BusConnects Dublin Core Bus Corridor Projects

Corridor 11 – Kimmage to City Centre

Emerging Preferred Route - Public Consultation Report 2018/2019

Section 1: KCR to Lower Kimmage Road / Sundrive Road [Kimmage Village].

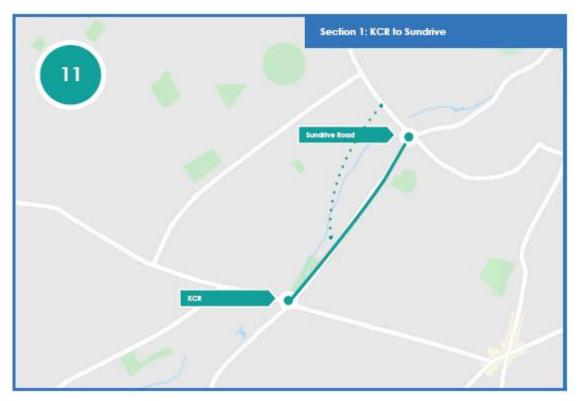
- Concerns over an increase in traffic along residential roads due to proposed bus gates; Concerns about fast cyclists on quiet roads;
- Concerns about the indirectness of the cycling route proposed;
- Concerns over reduced accessibility by car to their homes due to proposed traffic restrictions;
- Concerns over proposed widening of Lower Kimmage Road south of Sundrive Cross over a length of 0.5km, with land acquisition from approximately 40 properties to enable provision of bus lanes in both directions;
- Concerns about impacts on property values;
- · Objections to the loss of parking spaces;
- Safety concerns, including pedestrian safety concerns;
- Queries about bus services and the need for the scheme;
- · Community severance impacts; and
- Environmental impacts.

Section 2: Lower Kimmage Road / Sundrive Road [Kimmage Village] to Harold's Cross Park

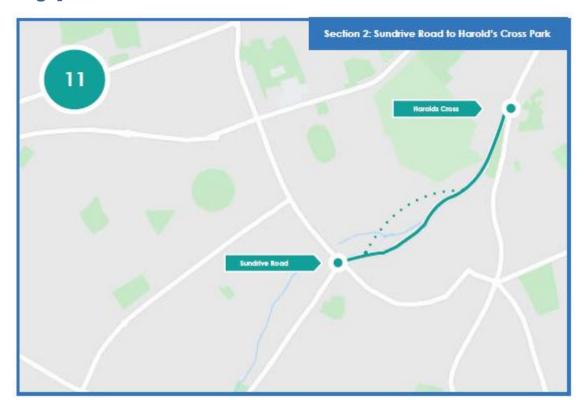
- Concerns over an increase in traffic along residential roads due to proposed bus gates; Concerns about fast cyclists on quiet roads;
- Concerns about the indirectness of the cycling route proposed;
- Concerns over reduced accessibility by car to their homes due to proposed traffic restrictions;
- Concerns about impacts on property values;
- Accessibility concerns to Mount Argus Church;
- Safety concerns at Harold's Cross National School due to traffic increases;
- General safety concerns, including pedestrian safety concerns;
- Queries about bus services and the need for the scheme;
- Flooding concerns at the River Poddle;
- · Community severance impacts; and
- Environmental impacts.

Section 3: Harold's Cross Park to the Grand Canal

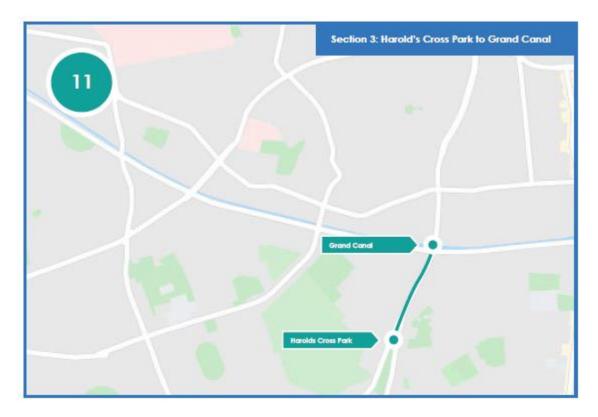
- Concerns over an increase in traffic along residential roads due to proposed bus gates; Concerns about fast cyclists on quiet roads;
- Objections to the proposed cycle route through the grounds of Our Lady's Hospice and along Greenmount Lane to Parnell Road at the Grand Canal.
- · Objections to the loss of parking spaces;
- Concerns about impacts on property values;
- Concerns over reduced accessibility by car to their homes due to proposed traffic restrictions;
- General safety concerns, including pedestrian safety concerns;
- Queries about bus services and the need for the scheme;
- Flooding concerns at the River Poddle; and
- Environmental impacts.

Section 4: Inside Canal

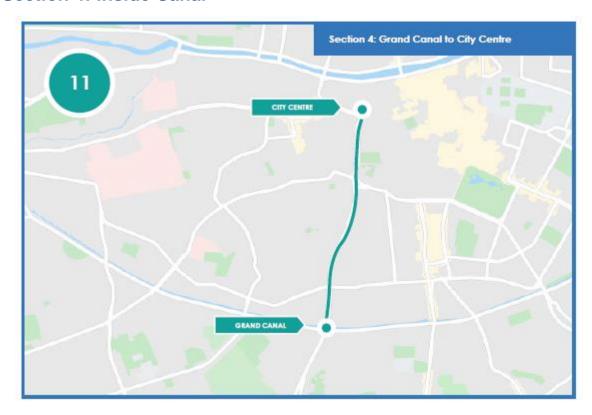
- Concerns about visual impacts of proposed bridges over the Grand Canal, including adjoining Robert Emmet Bridge on Clanbrassil Street;
- Concerns over reduced accessibility by car to their homes due to proposed traffic restrictions;
- · Concerns about possible road widening;
- · Objections to the loss of parking spaces;
- Queries about bus services and the need for the scheme;
- General safety concerns, including pedestrian safety concerns;
- Objections to the proposed closure of Heytesbury Street;
- Concerns about an increase in traffic on Pleasant Street; and
- Concerns relating to the need for cycling facilities on Clanbrassil Street.
